BIG TWIN STARTER FASTENERS

Figure 1. Fretting

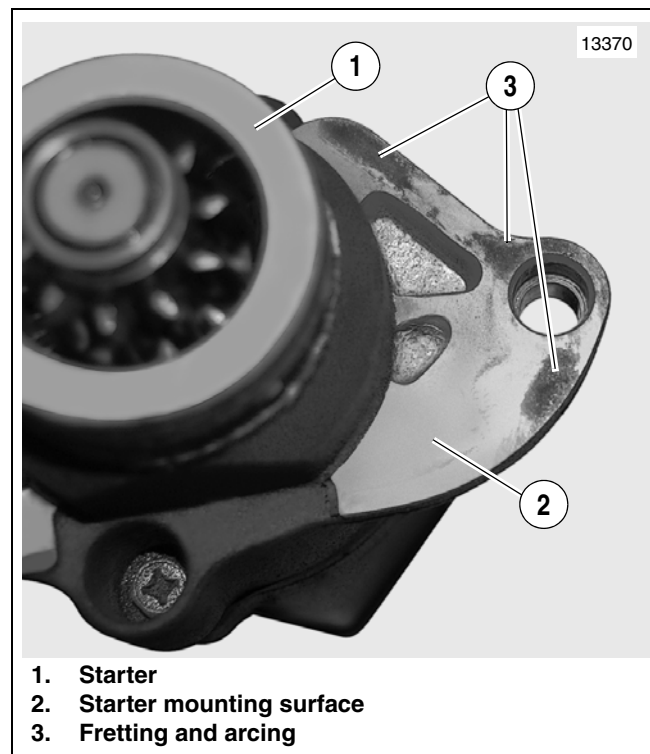
2. See Figure 1. Inspect starter mounting surface (2) and matching area on inner primary for fretting and arcing (3) which is a pitting condition caused by insufficient ground.
3. Clean fretting on starter and mating surface with a dry abrasive pad.
